ADDENDUM NO. B

Colton MS Administration Modernization & New Locker Room Building – DSA App #04-123792)

Colton MS Pavillion – DSA App #04-123039

Colton Joint Unified School District
1212 Valencia Drive
Colton, CA 92324

ENLARGED RESTROOM PLANS
& INT ELEV'S

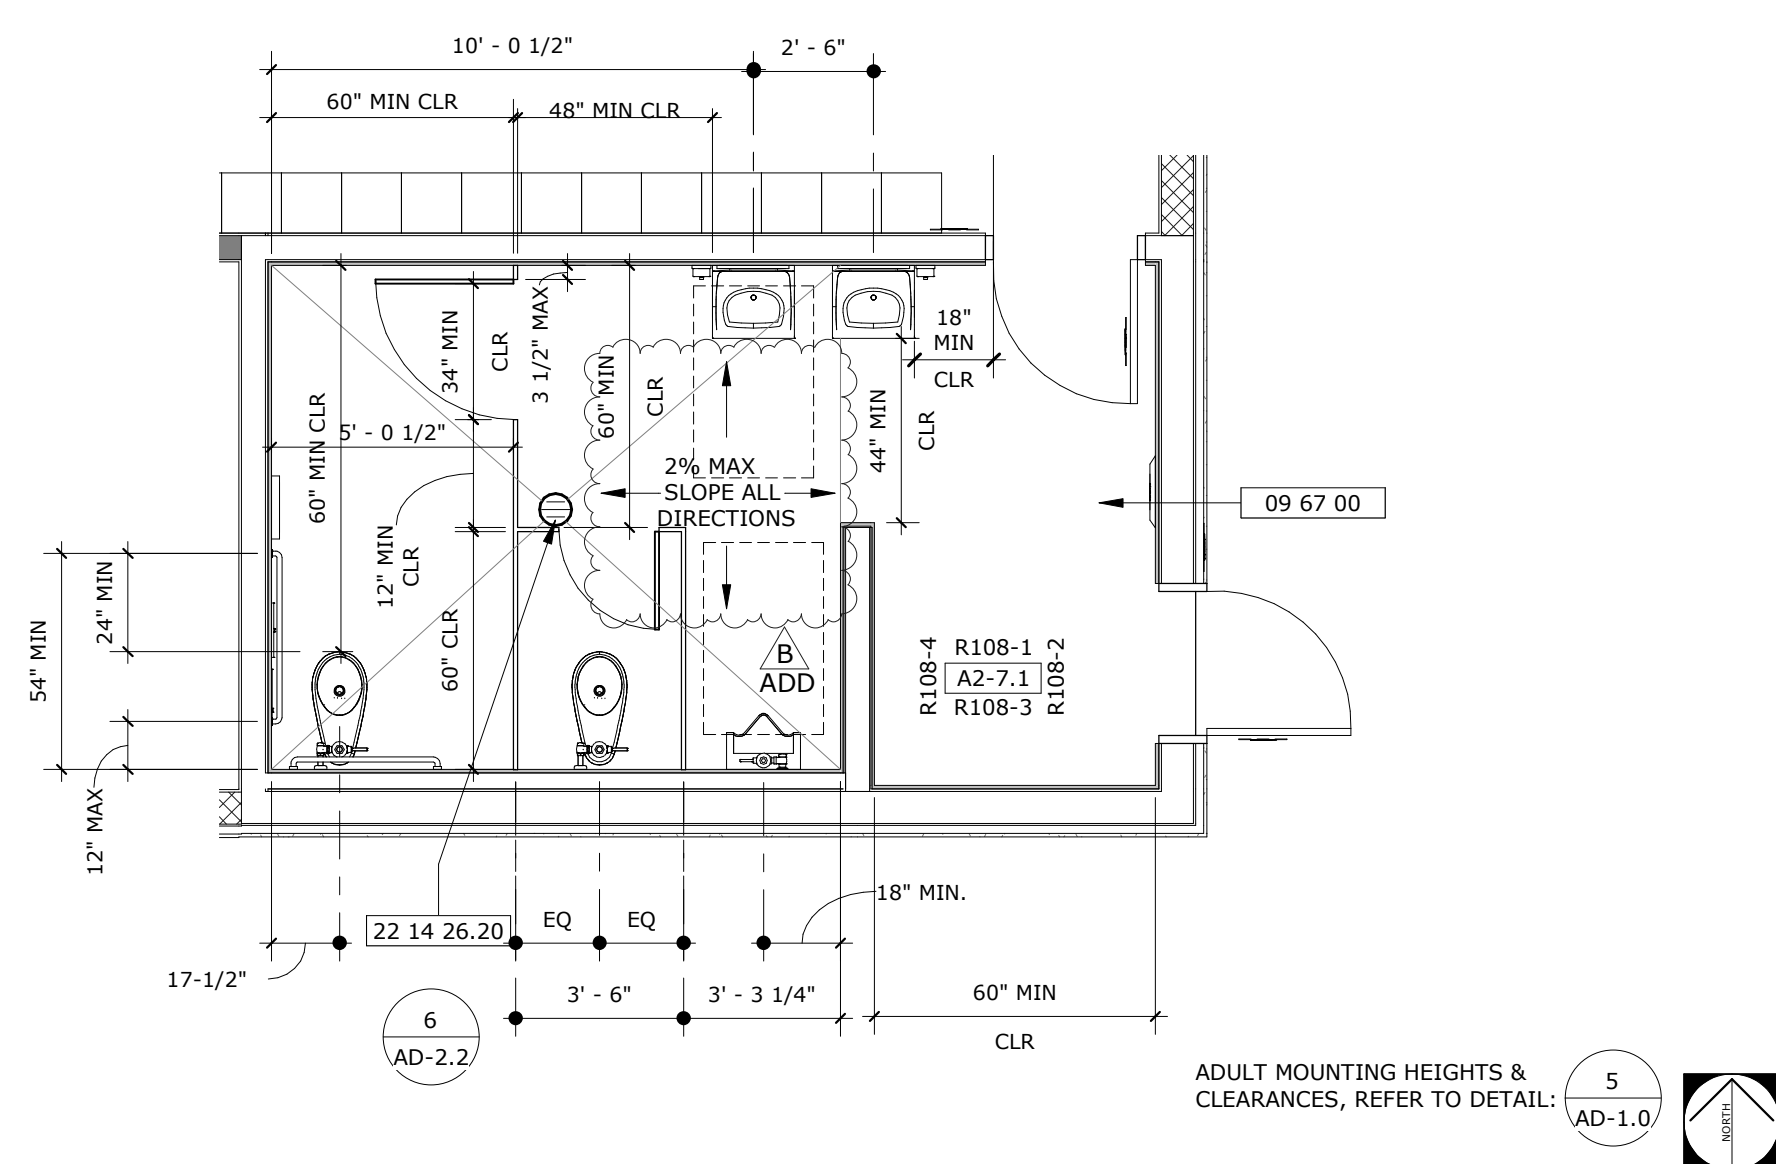
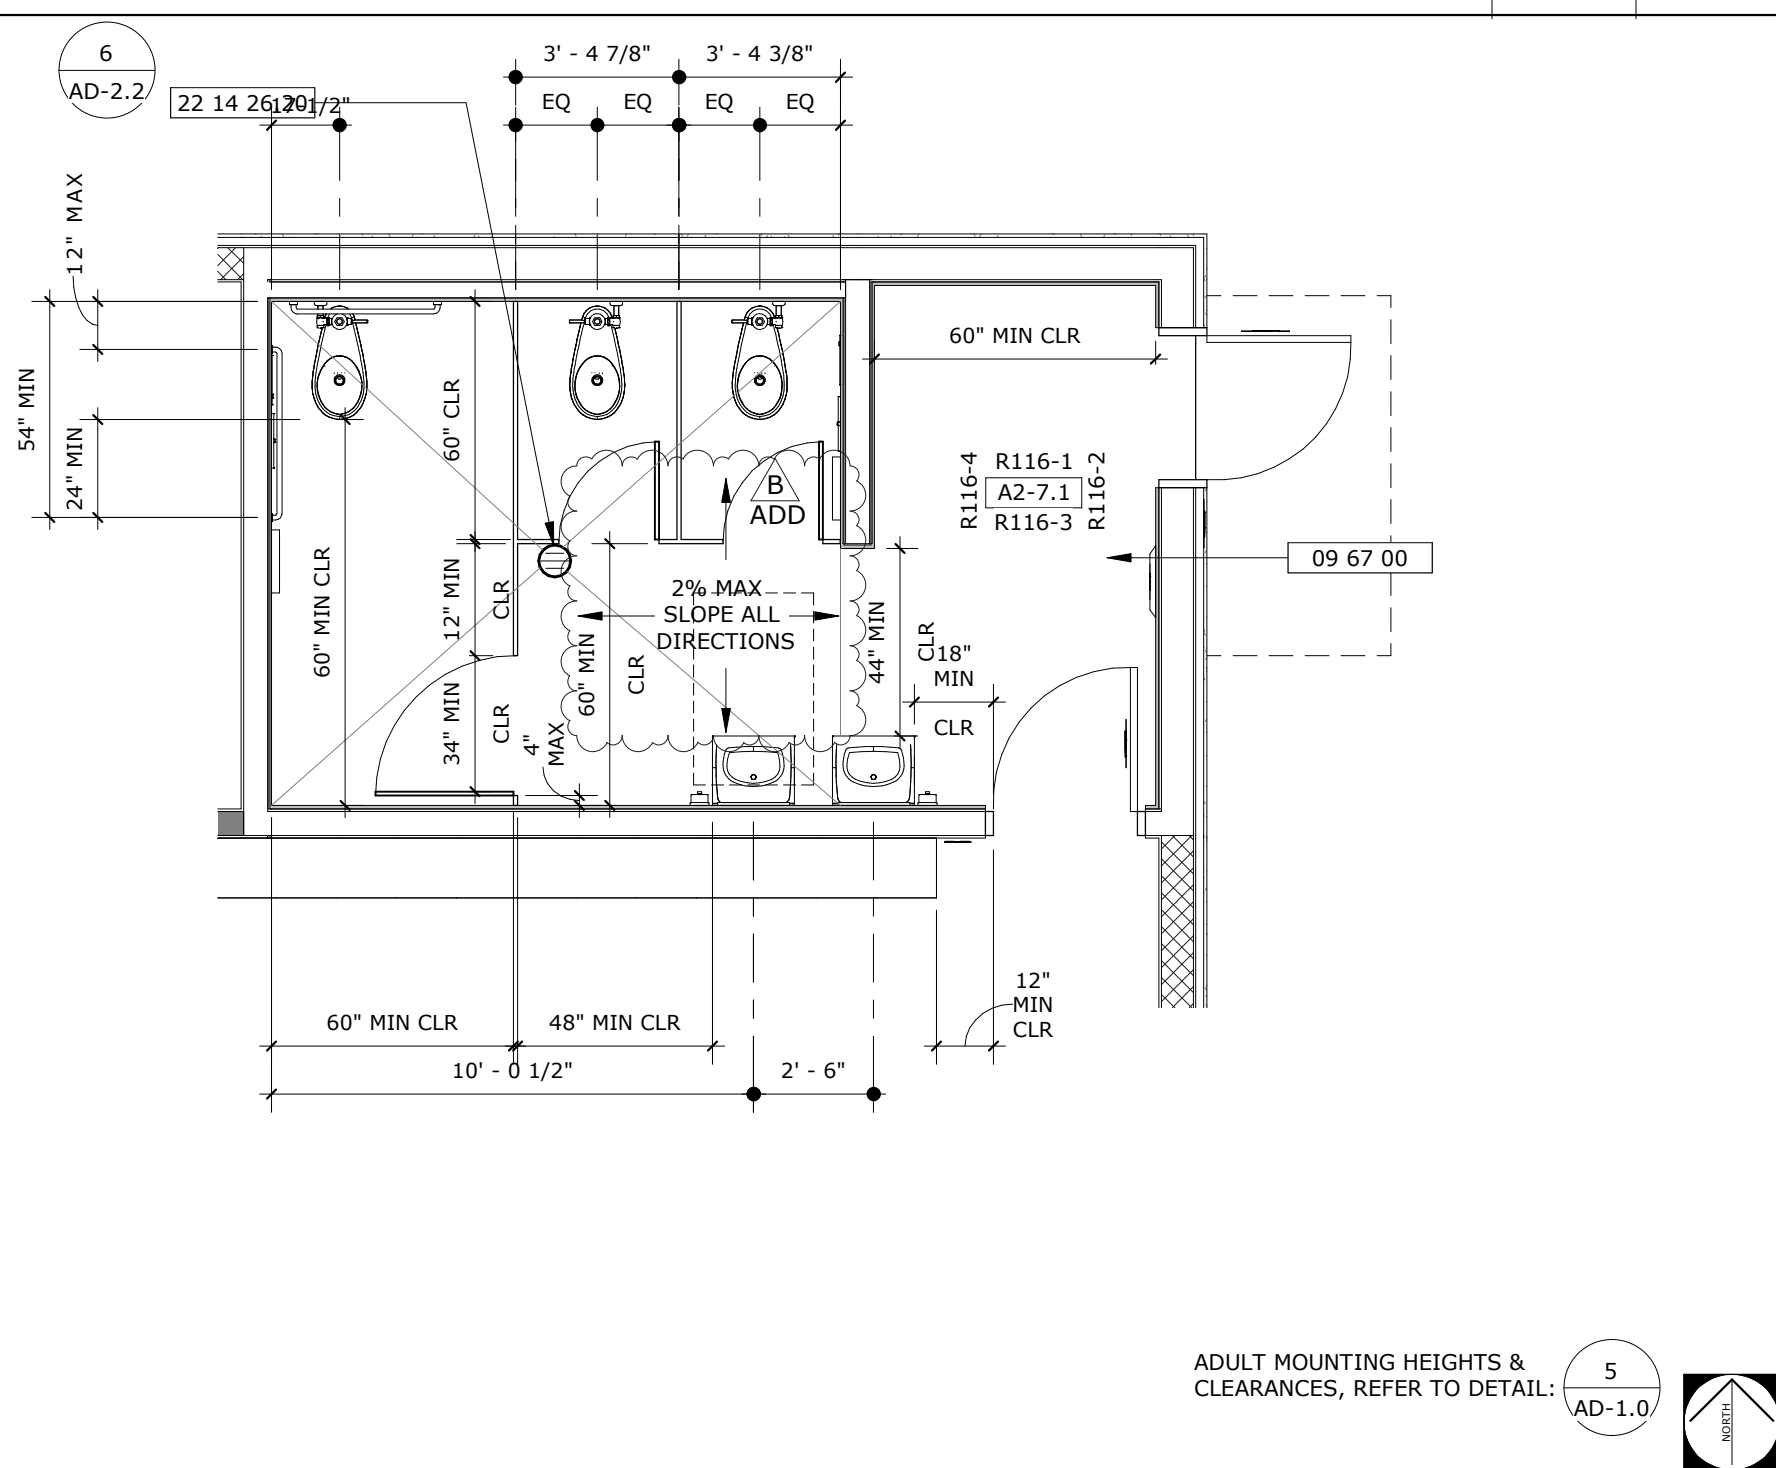
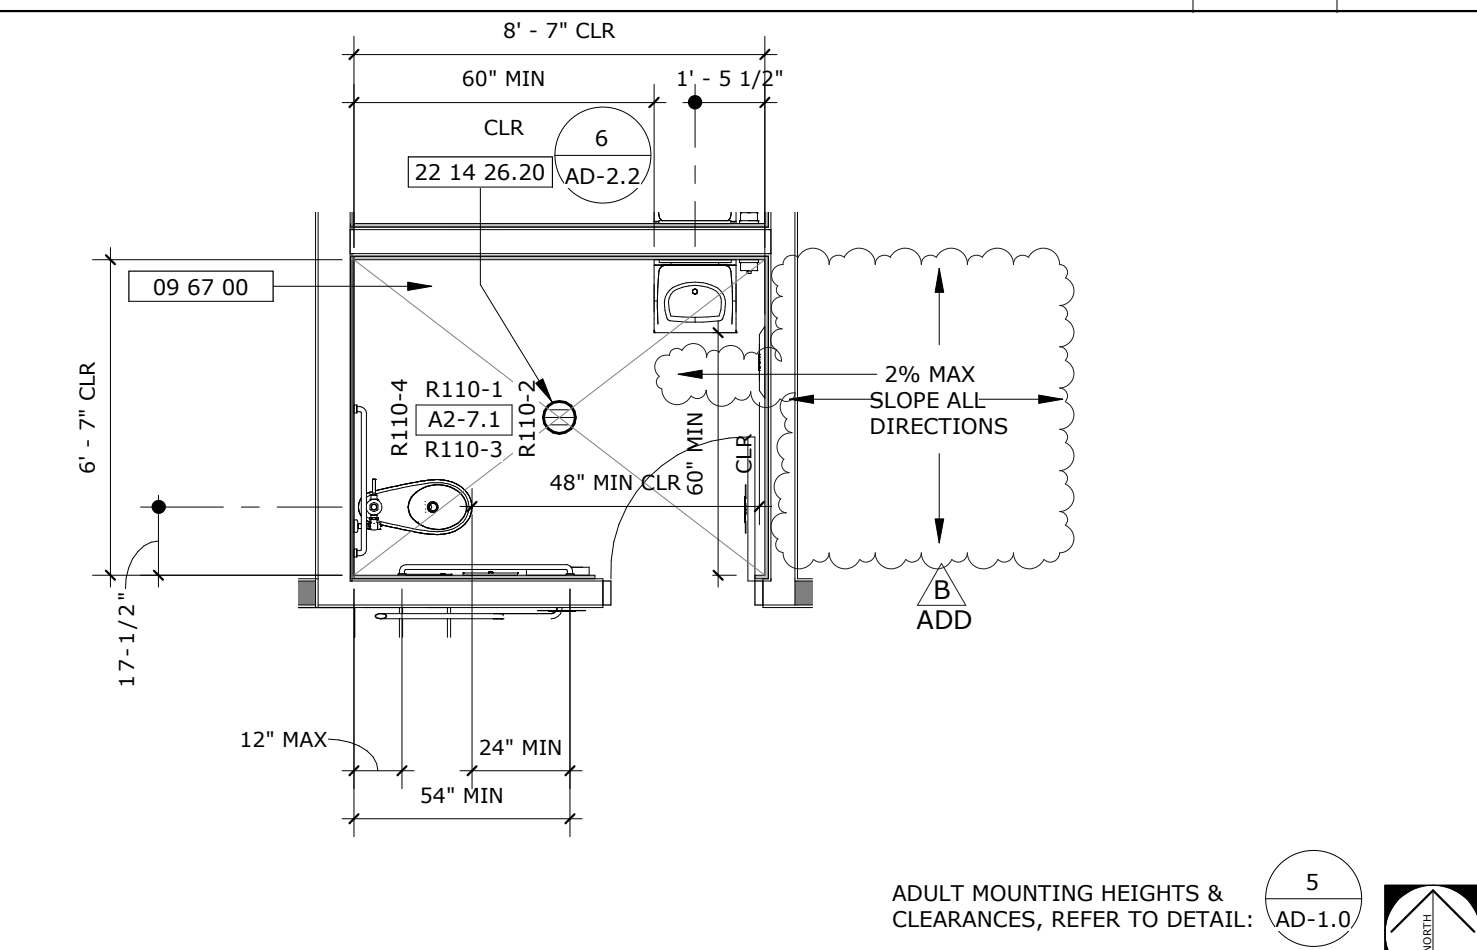
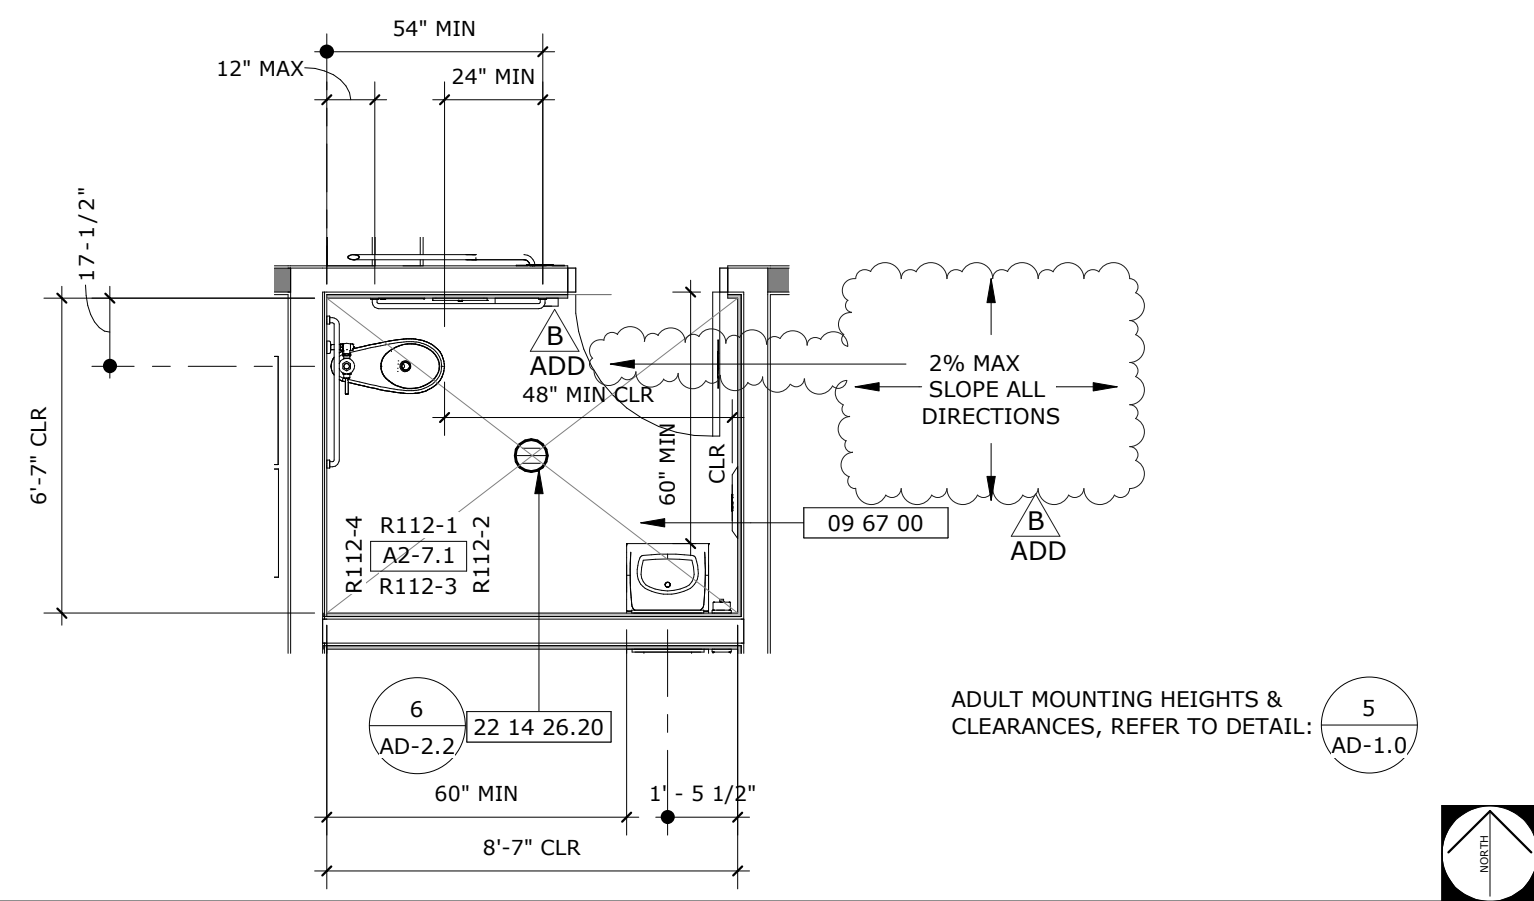
- Item No. B.23 Reference Sheet A1-7.1 – Enlarged Restroom Plans & Int Elev's:
- B.23.1 Revised Detail 7, 8, 9 & 10 per clouded areas.

ADMIN. BLDG.
ROOF FRAMING PLAN

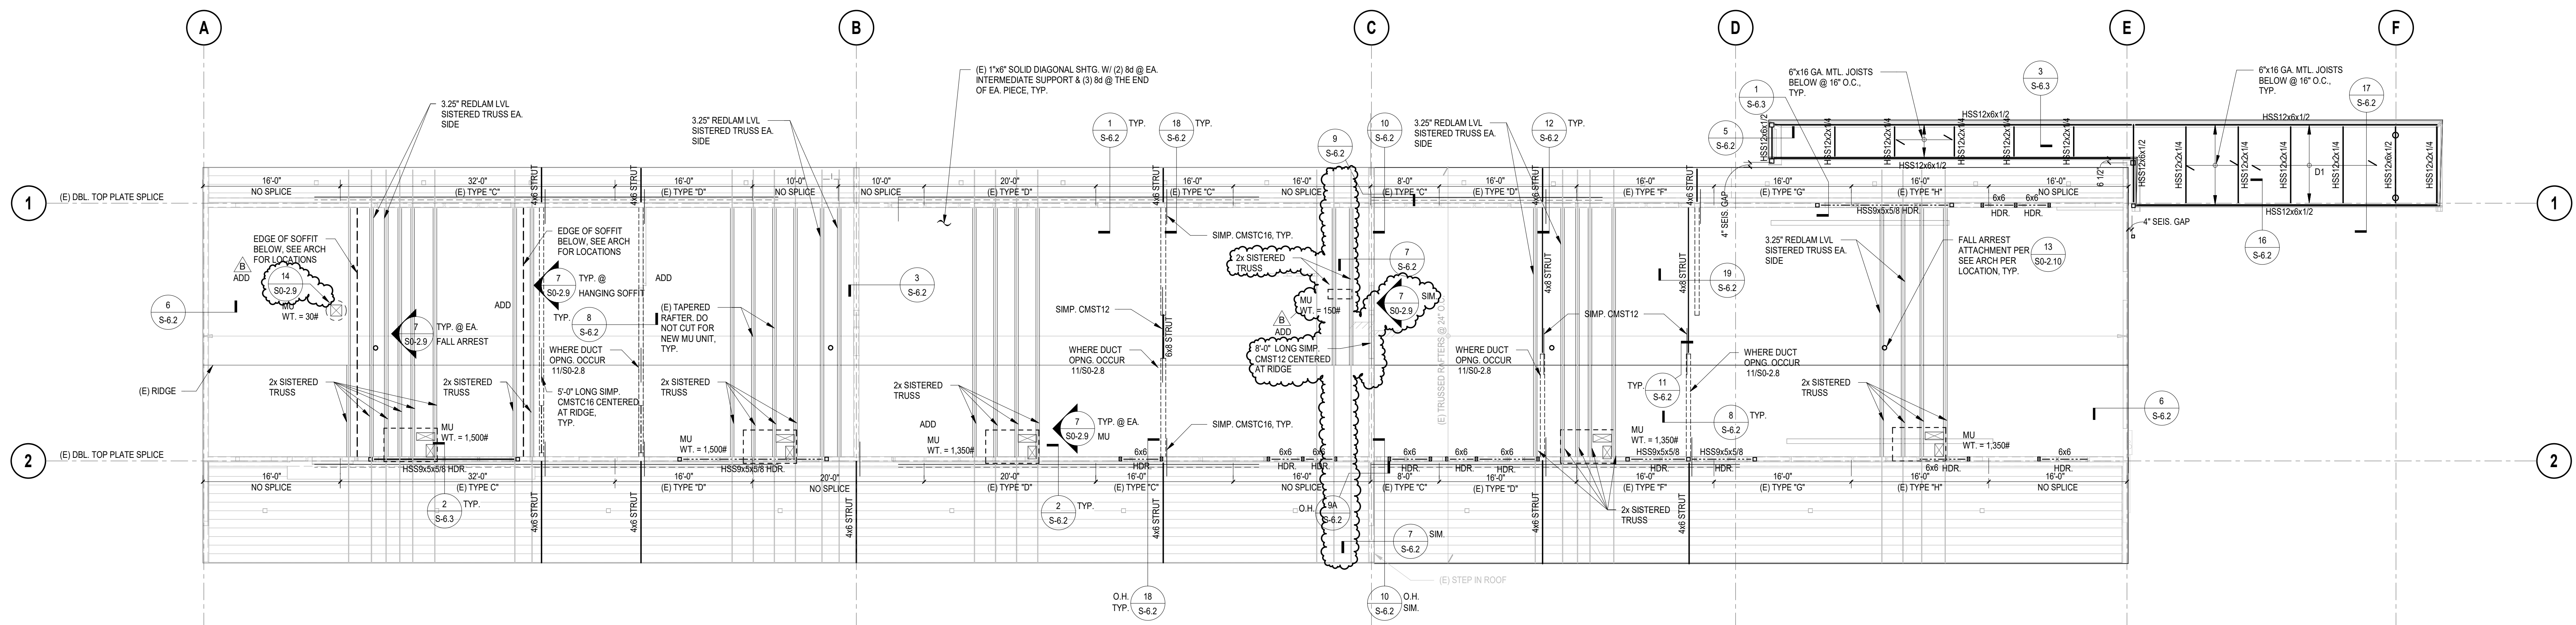
- Item No. B.30 Reference Sheet S1-3.0 – Admin. Bldg. Roof Framing Plan:
- B.30.1 Revised roof framing per clouded areas.

1 PLUMBING - ADMIN BLDG FLOOR PLAN - REMODEL

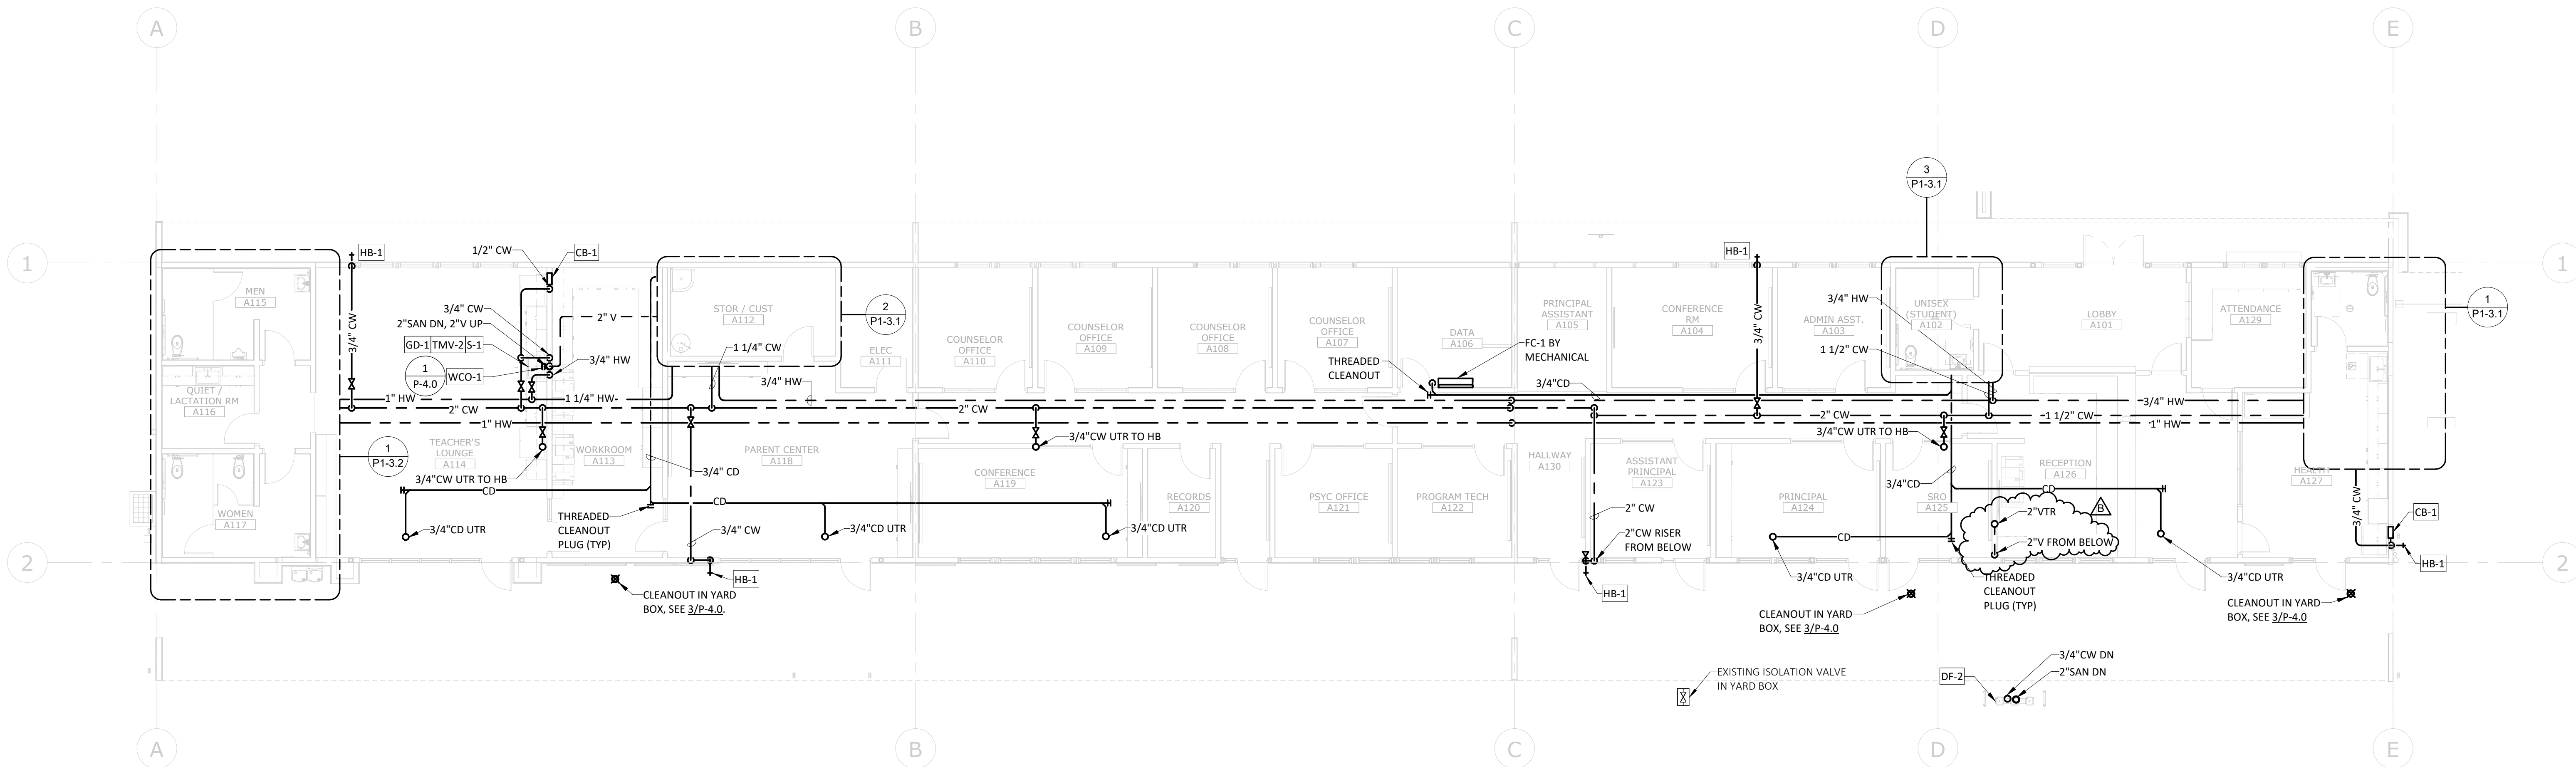
- Item No. B.32 Reference Sheet P1-1.1 – Plumbing – Admin Bldg Underfloor Plan – Remodel:
 - B.32.1 Revised per clouded areas of attached sheet and items listed below.
 - a) Revised location of the below grade vent and riser to offset up at the interior wall in lieu of the exterior wall.
- Item No. B.33 Reference Sheet P1-1.2 – Plumbing – Admin Bldg Floor Plan – Remodel:
 - B.33.1 Revised per clouded areas of attached sheet and items listed below.
 - a) Revised location of the vent riser to offset up in the interior wall in lieu of the exterior wall.
- Item No. B.34 Reference Sheet P1-2.1 – Plumbing – Admin Bldg Roof Plan – Remodel:
 - B.34.1 Revised per clouded areas of attached sheet and items listed below.
 - a) Revised location of the vent through roof.
